Access Compliance Report

Public Rights-of-Way

(Curb Ramps)

Intersection ID: N/A	Main Street: MILLENNIUM_AV	Cross Street: CITY_PARK_DR	Location: SE
ADA ID: E17E7C3DF399	Ramp Type: MedianPerp	Initial Pass/Fail: Fail	Overall Compliance: No
Severity Score: 1.25			
Codes/Mitigation Info/Possible Solution		Field Measurements/Component Compliance

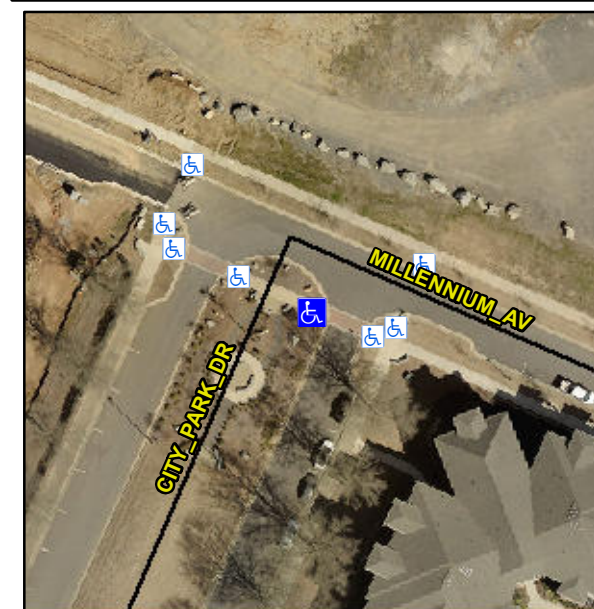
Not Found, R304.5.3

Compliance	Description	Data	Compliance	Description	Data
N/A	Ramp Length (in)	156.0	Yes	Ramp Slope (%)	6.8
Yes	Ramp Width (in)	70.0	No	Ramp XSlope (%)	2.8
N/A	Flare Type LT	N/A	N/A	Flare Type RT	N/A
N/A	Flare Slope LT (%)	N/A	N/A	Flare Slope RT (%)	N/A
N/A	Flare Traversable LT?	N/A	N/A	Flare Traversable RT?	N/A
N/A	Landing Length (in)	N/A	N/A	DWS Provided?	N/A
N/A	Landing Width (in)	N/A	N/A	DWS Contrast?	N/A
N/A	Landing Slope (%)	N/A	N/A	DWS Length (in)	N/A
N/A	Landing X Slope (%)	N/A	N/A	DWS Full Width?	N/A
N/A	Landing Curb? (Y/N)	N/A	N/A	DWS Offset (in)	N/A
N/A	Shared Landing?	N/A			
N/A	Gutter Ponding?	N/A	N/A	Gutter Slope (%)	N/A
N/A	Gutter Lip Ht (in)	N/A	N/A	Gutter X Slope (%)	N/A
N/A	Painted X Walk1?	Yes	N/A	Painted X Walk2?	N/A
	X Walk 1 Direction	To SE		X Walk 2 Direction	N/A
N/A	X Walk 1 Width (in)	84.0	N/A	X Walk 2 Width (in)	N/A
	X Walk 1 Slope (%)	0.4		X Walk 2 Slope (%)	N/A
	X Walk 1 X Slope (%)	3.0		X Walk 2 X Slope (%)	N/A

Remove & Replace Entire Ramp.
